## ADDENDUM NO. 1

**DATE: January 16, 2014**

Contract 14-C-00011; Channel District: East Madison Street Improvements  
Project 1000327

**Reference: Questions for Contract 14-C-00011**  
**Channel District: East Madison**  
**Street Improvements-Project 1000327 [ADDENDUM #1]**

E. MADISON STREET IMPROVEMENTS  
 UTILITY ADJUSTMENT (2 OF 3)

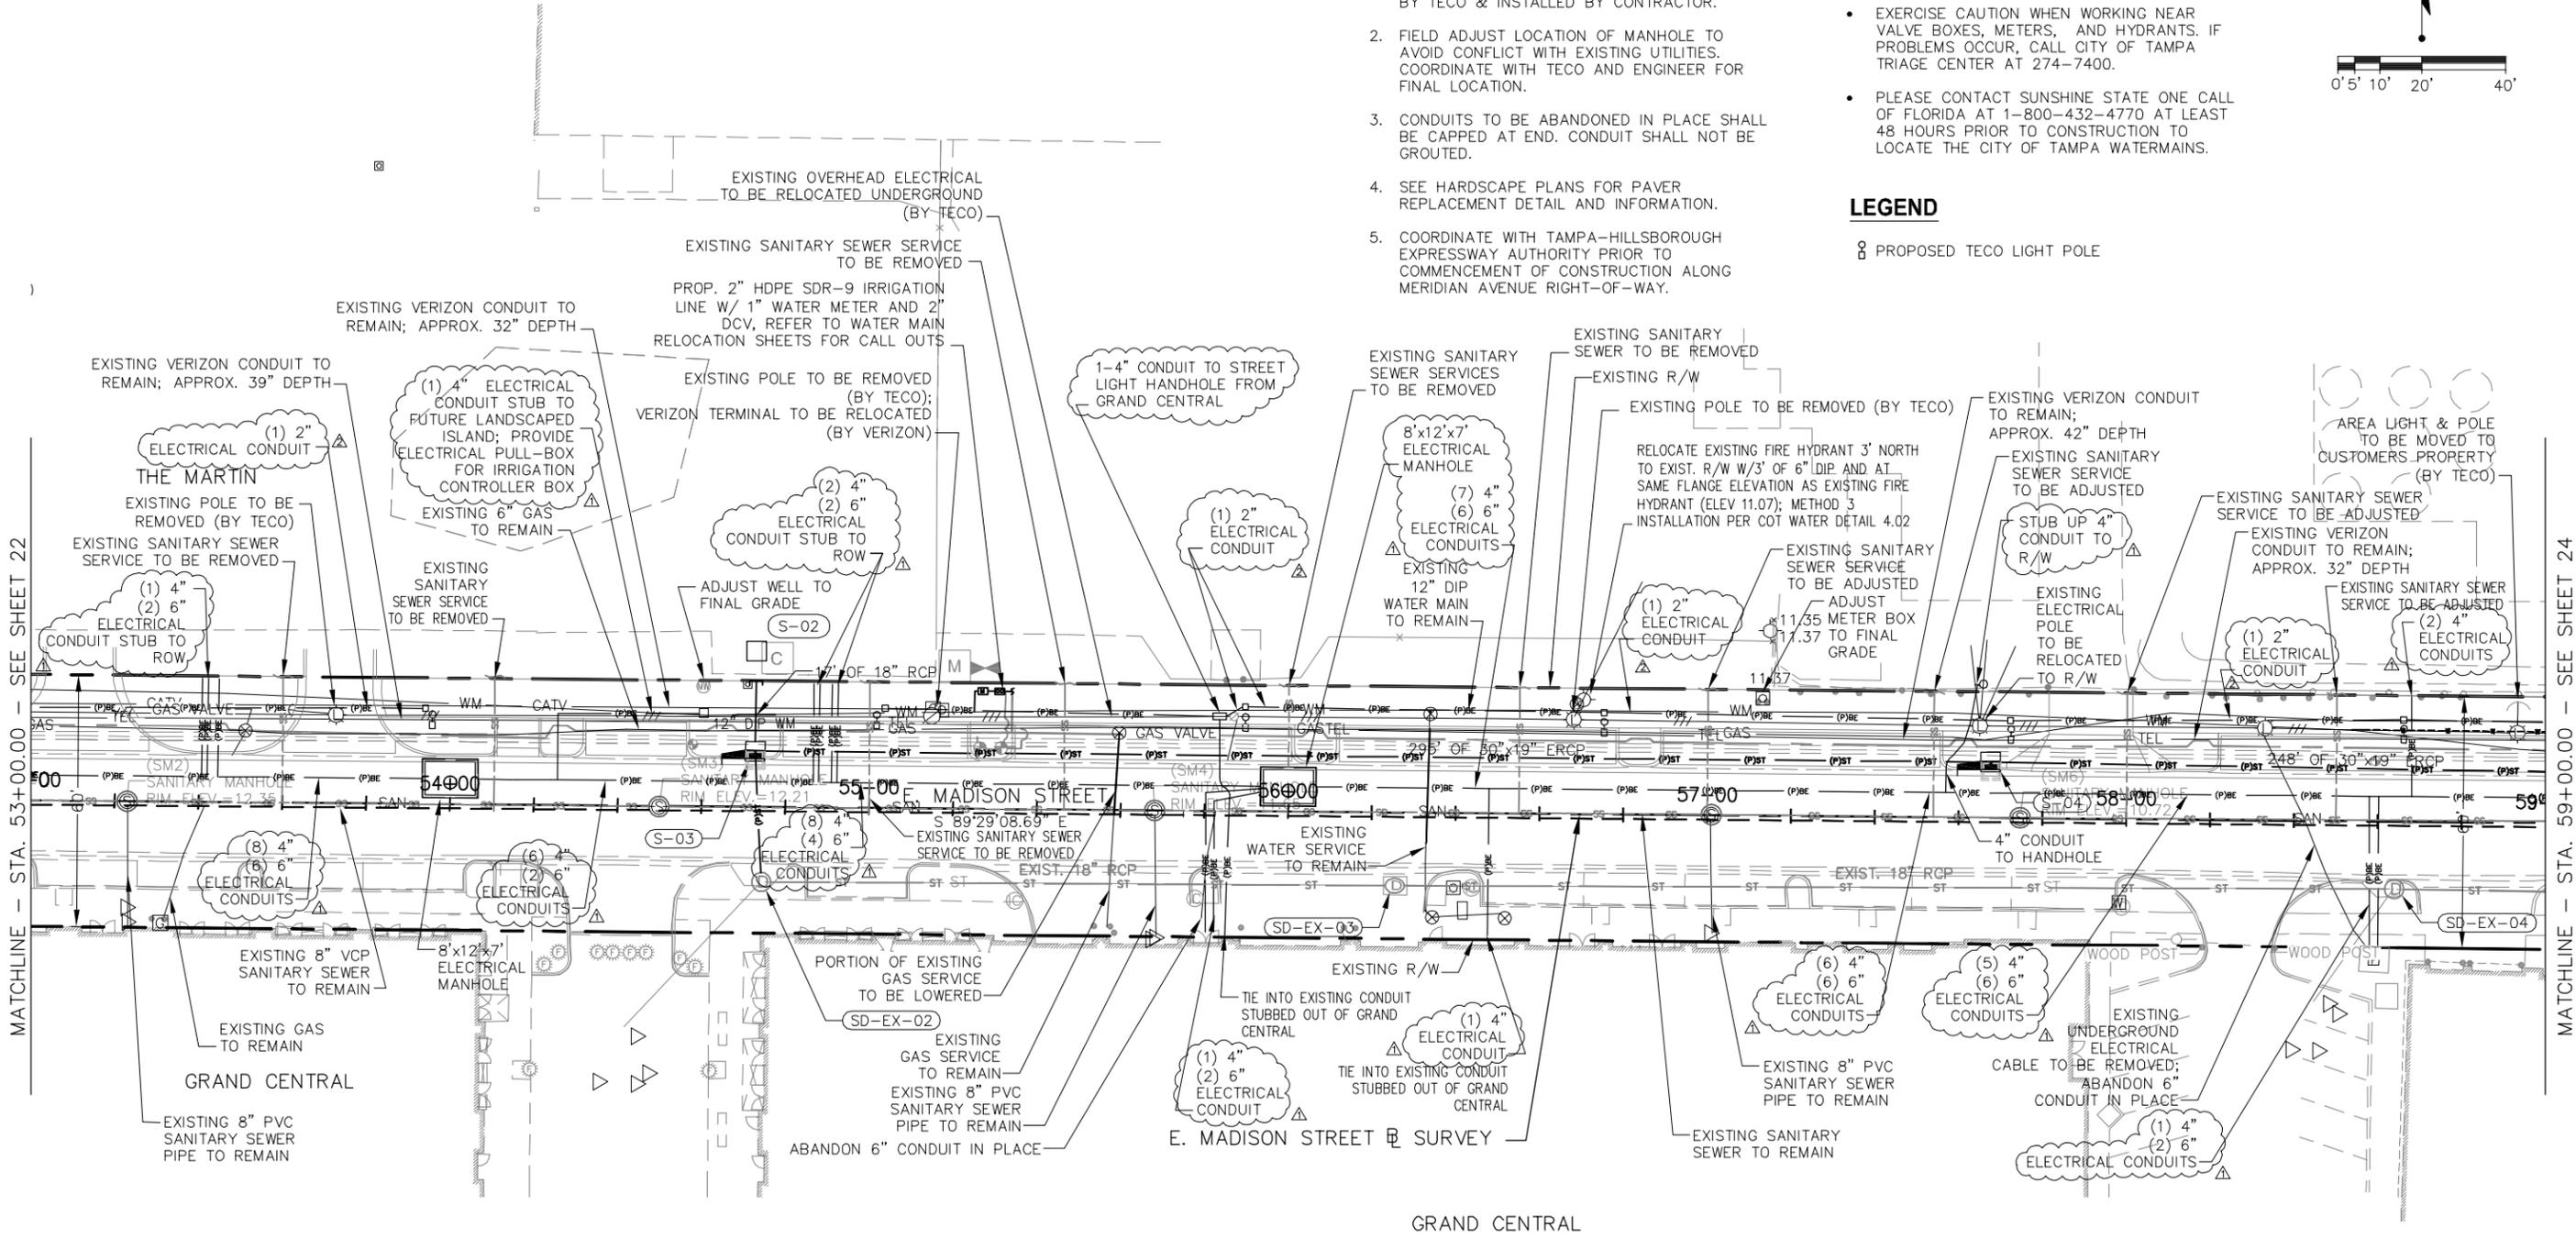
2. There are proposed electrical conduits shown running to the south just west of the electric manhole located at Sta. 53+00. There does not appear to be a call out for what size these are or how many. Can you provide that information?

3. Can you tell us where on the plans we might find the work associated with pay item SP-5.04-1, 2" conduit, Lighting, Install Underground?

***Stantec Response:*** *Those electrical conduits are: 2-4" conduits and 2-6" conduits and are shown on the revised Utility Adjustment sheet.*

***Stantec Response:*** *Those conduits are associated with the proposed street lighting for East Madison Street and are now shown on the revised Utility Adjustment sheets.*

E. MADISON STREET IMPROVEMENTS  
WATER MAIN RELOCATION (1 OF 2)

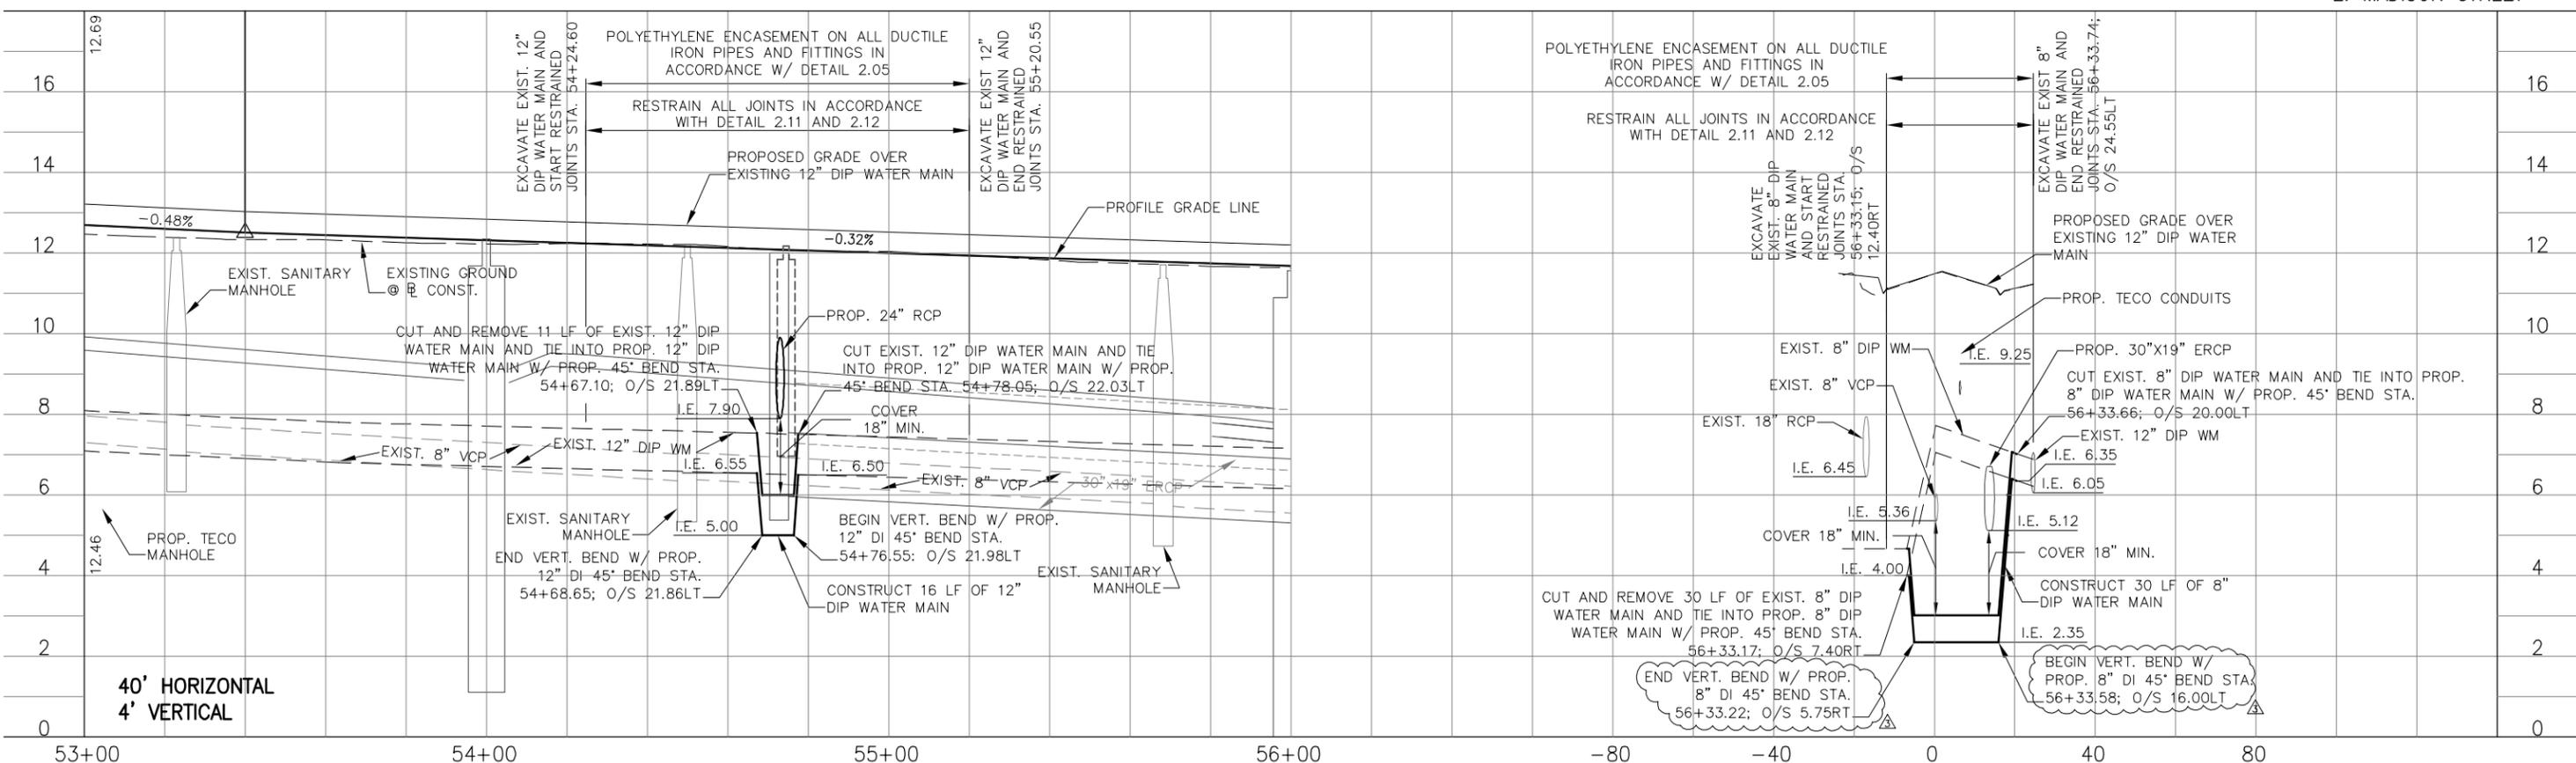
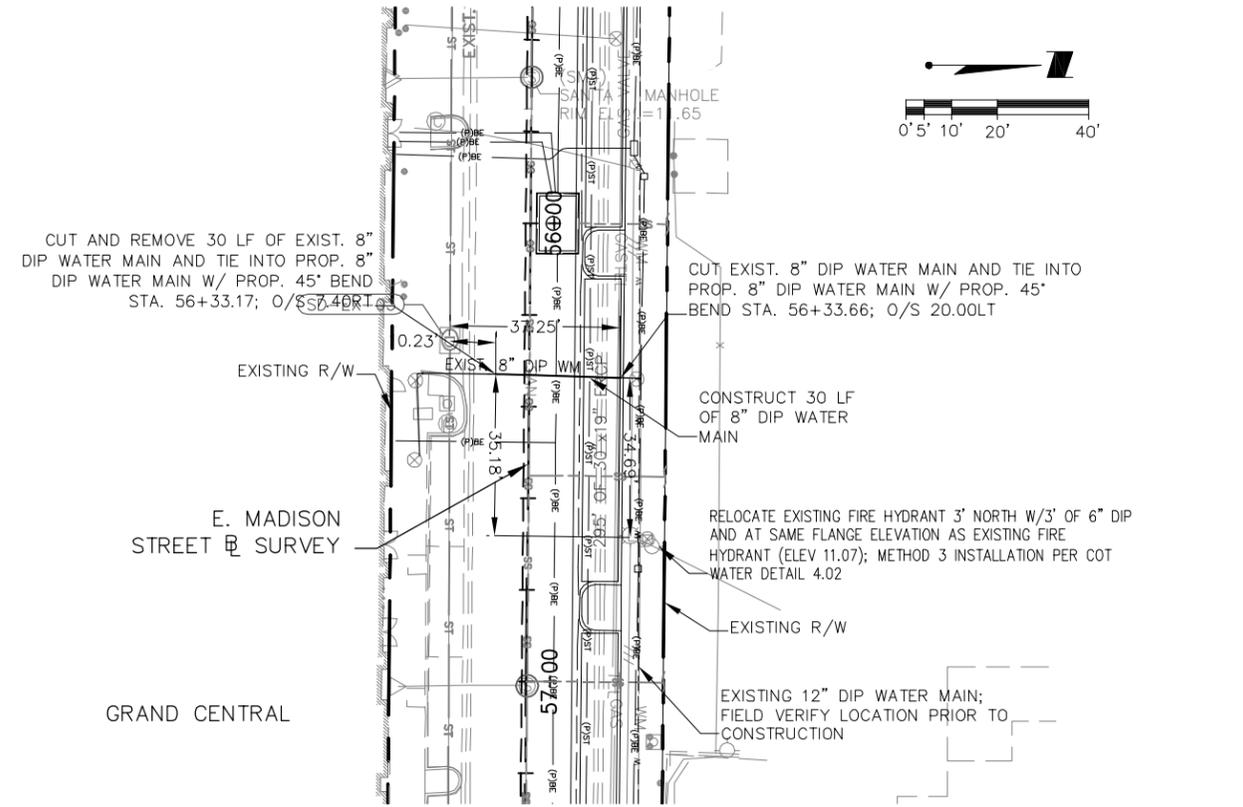
On plan sheet 27, lower right, there is a profile view of a proposed offset for the water main. The callouts variously refer to the size of the pipe and fittings as being 8" or 12". It would seem logical that it is one size or the other, not a mix of the two. Please clarify that we are correct and all of the pipe and fittings involved in this offset are 8".

**Stantec Response:** *All of the call-outs for the fittings in the lower right corner profile are to be 8". See sheet 27.*
